Re: Addendum, Zoning Bylaw Amendment at 105-111 Edgehill Drive
Municipal File No. D14-1653, IPS File No. 14-499

EDGEHILL DRIVE TOWNS

ADDENDUM REPORT

105 – 111 Edgehill Drive, Barrie
PL 23, CON 6 (Former Township of Vespra), Barrie
IPS NO. 14-499

CONCEPTUAL SITE PLAN - 63 UNITS
EDGEHILL DRIVE & ANNE ST N, BARRIE

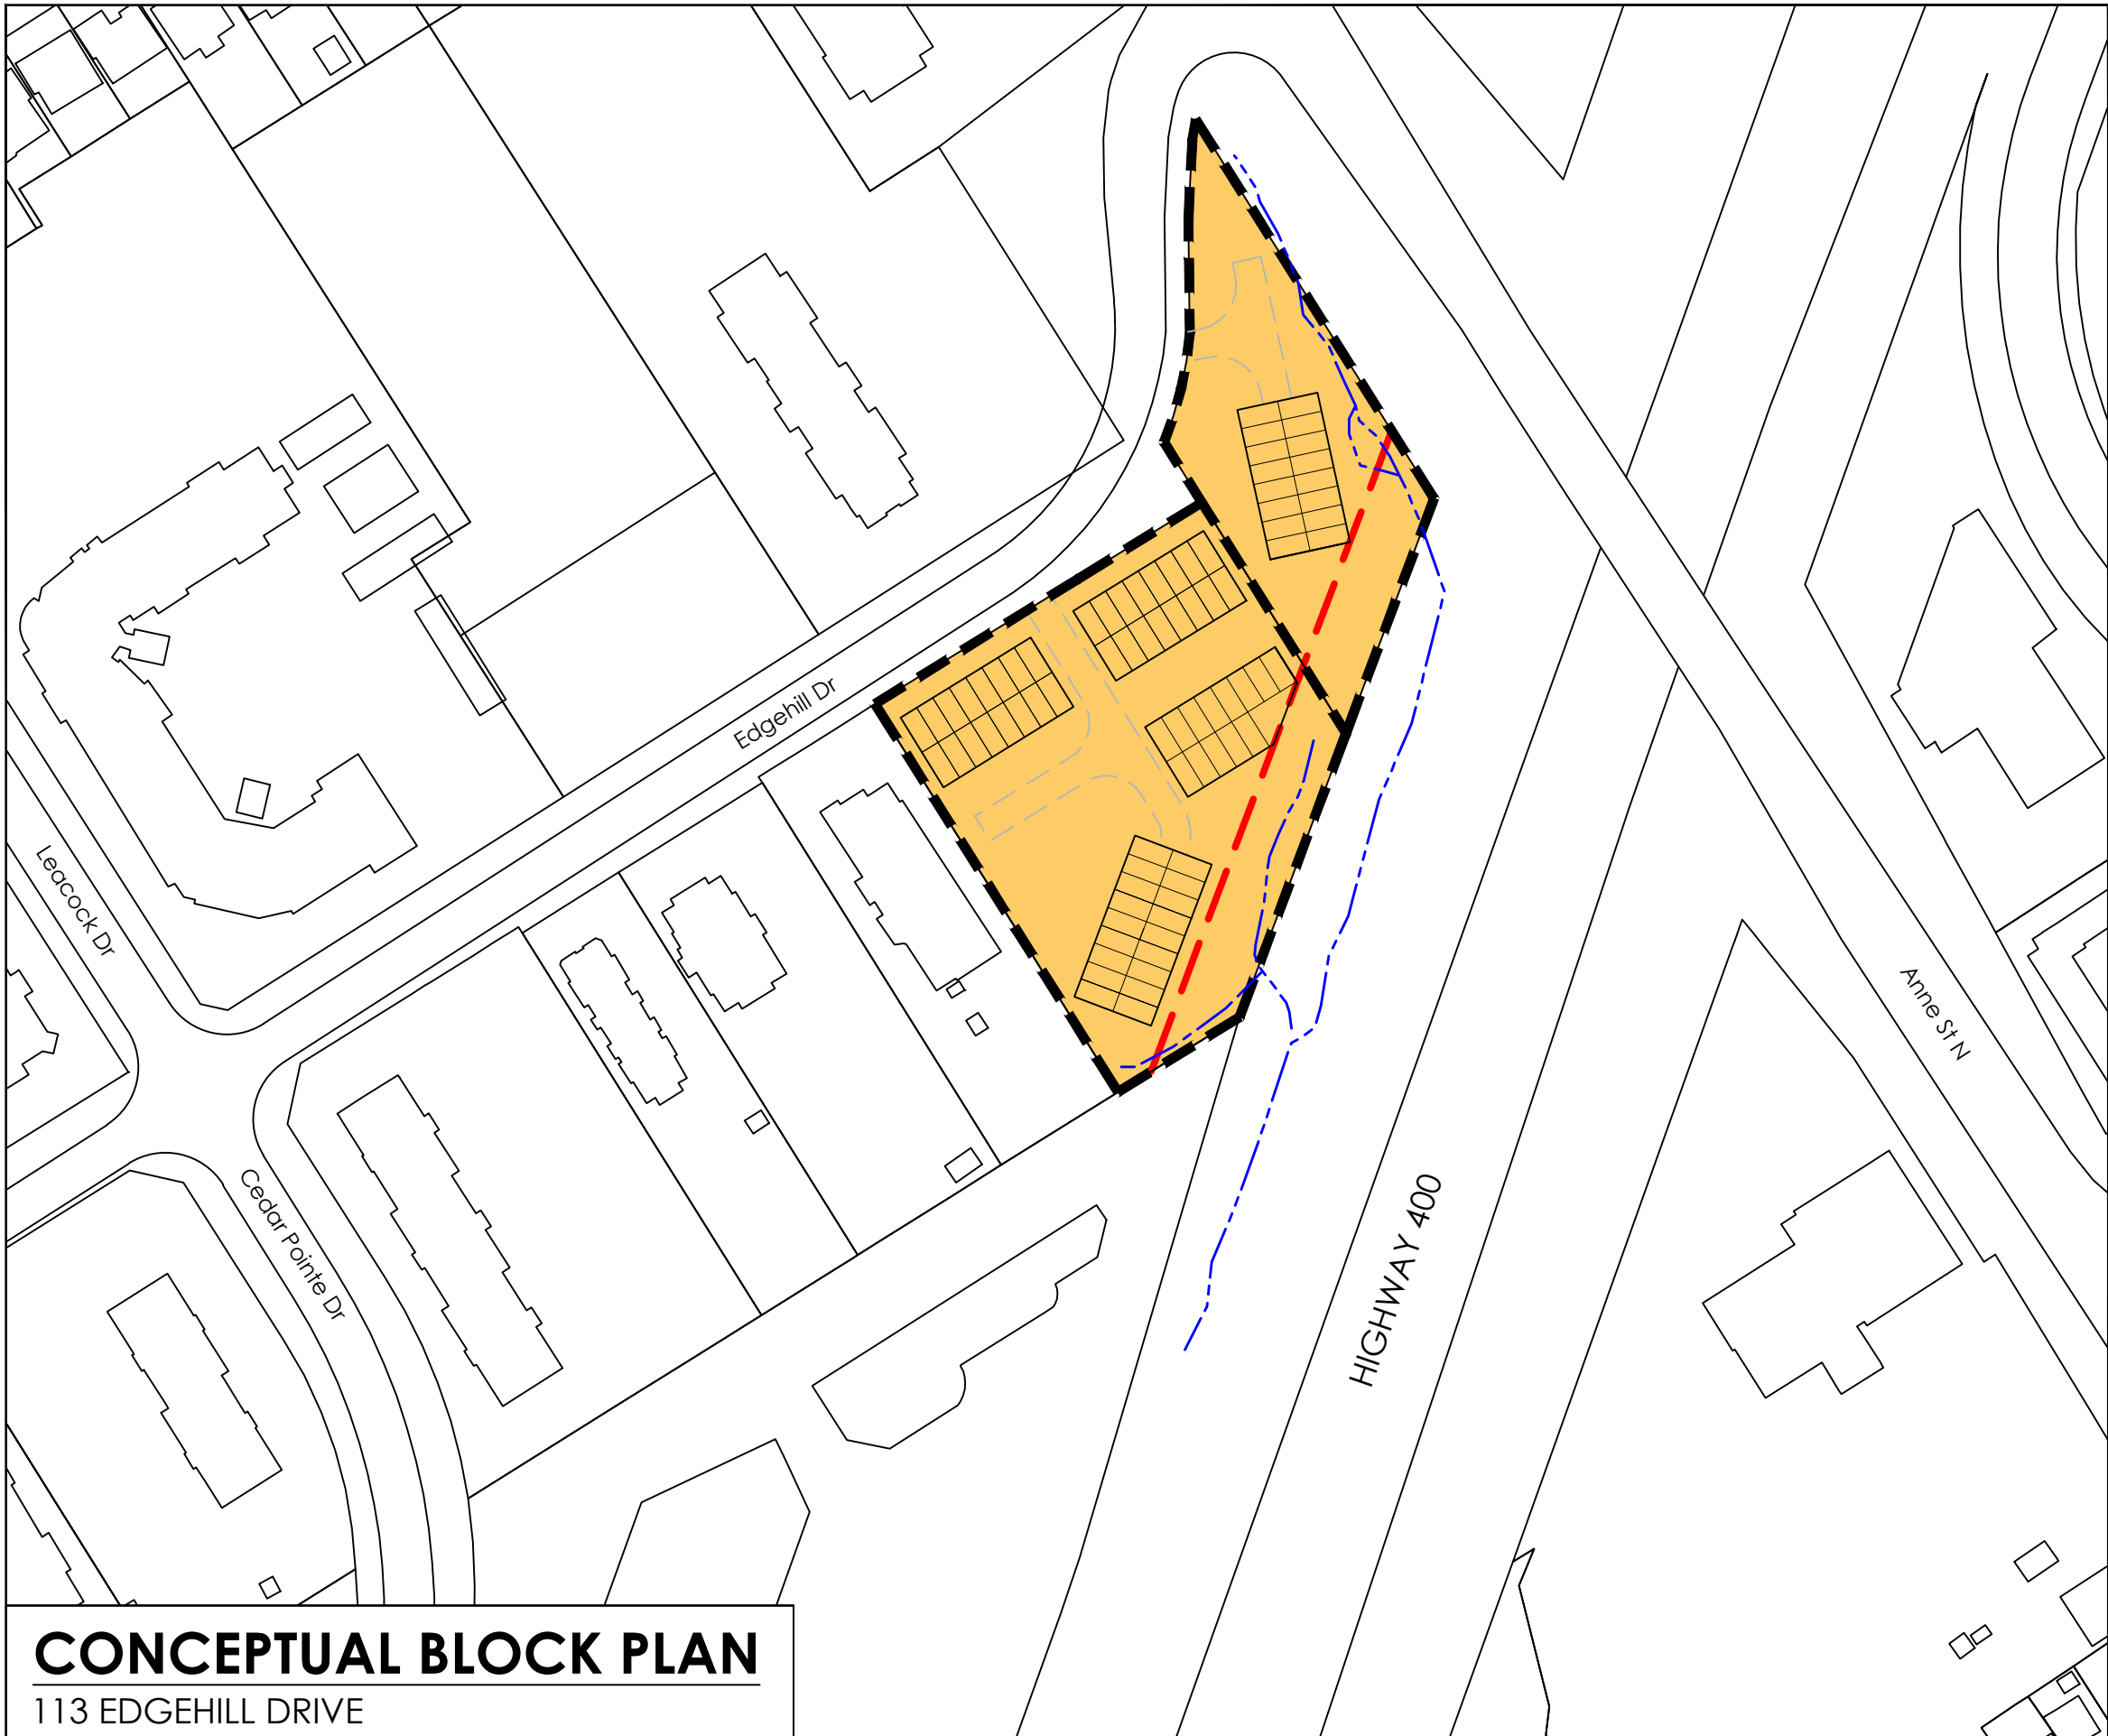
27	It is critical that the amenity space that is provided is usable, centralized, and accessible. Long linear spaces are not considered usable and will require a redesign. It is critical that parks planning agree to any unconsolidated amenity space, including their size and configuration. The sound walls as required by the noise study (Valcoustics Canada Ltd. June 26, 2018) are not acceptable.	Amenity space has been increased in the resubmission. Both amenity 'blocks' would support tangible uses.

9. SITE DESIGN		
32	The limits of development will be confirmed through the LSRCA.	Confirmed.
33	The sidewalks do not connect to the municipal sidewalks along Edgehill Drive. This must be rectified. The sidewalk must be 1.5 metres in width, with rounded edges.	All units now have formal pedestrian access to municipal sidewalks through the internal walkway configuration.
34	The required acoustic barriers along the eastern limit of amenity areas B and C are not acceptable. They create urban design and safety concerns and will not be accepted.	Sound barrier fencing is not required according to MECP noise guideline requirements. See Addendum No. 1 to the noise study for additional information.

No.	Municipal Comment	Response
35	The site seems to be an over development for this built form there is insufficient parking, no space for garbage collection, sidewalks do not connect, and the amenity spaces are awkward and unconsolidated. These items need to be addressed in order to move forward.	These critiques are addressed through the redesigned site. A parking study has been completed by C.C. Tatham & Associates Ltd.
36	The sound wall needs to be identified on the site plan to allow for proper review. Most commenting agencies and departments will not know that it is required as they would not have reviewed the noise study.	Sound barrier fencing is not required according to MECP noise guideline requirements. See Addendum No. 1 to the noise study for additional information.
37	The sidewalk on Building #3 cuts into the required MTO setback. Please confirm with MTO that this acceptable and that there is no risk of losing that pedestrian connection in the future.	As of the redesign no required sidewalk or permanent built element is proposed within the future MTO setback.

Based on the feedback received the development concept has been reduced from 78 to 63 units, configured in four blocks. A 6.4m condominium road runs centrally through the site connecting both surface and underground parking facilities to Edgehill Drive. This entrance has not been modified from the initial submission. Each unit is provided with one parking space below the respective residential unit. An additional 17 spaces (4 accessible) are provided as surface parking. The reduced density and increased surficial parking yield a parking ratio of 1.25 spaces/unit, up from a ratio of 1.07 spaces/unit at the time of the previous submission. The front yard setback has been increased to 5.50m with this amendment in order to ensure adequate spacing from the transportation protection zone required by the City. Once this road widening is realized, the development will possess a 2.0 metre front yard setback. On-site Molok® bins for private collection are expected to satisfy condominium demand and are located to accommodate truck movements. The main amenity space has been centralized and enlarged in order to provide a consolidated gathering place. All internal noise 'fencing' has been removed from the current submission. Internal walkways will connect all units to the pedestrian sidewalk along Edgehill Drive.

The revised proposal accommodates a 14-metre setback from the future Highway 400 road allowance as requested by MTO. Specific landscaping elements and details on buffering will be confirmed at the site plan stage. Further, private outdoor amenity area is provided to units through the provision of third-floor balcony areas.

The unnamed tributary of Bunkers Creek has been relocated since the initial submission. The relocated tributary is proposed to be naturalized using native flora as per the substance of the Technical Design Brief submitted by Geomorphix. The revised concept plan can be reviewed under Figure 1 and Section 3.0.

CONCEPTUAL BLOCK PLAN

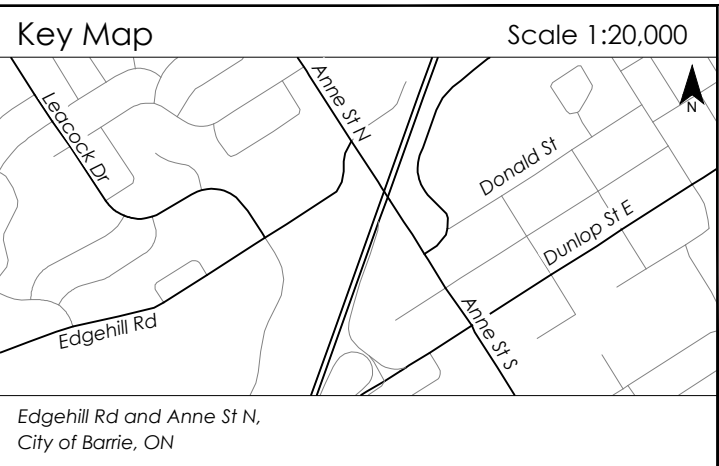
7. CONTEXT		
30	The surrounding areas are high density residential developments. However, 103 Edgehill Drive is the last remaining single detached residence in the area. Please demonstrate how this parcel can develop in the future in a manner that is compatible with this proposal.	This statement is not correct. There exist a number of medium density developments along Edgehill Drive on the same side of the road as the subject lands. A block plan has been prepared to show how 103 Edgehill might be developed in a way compatible with the proposed concept.
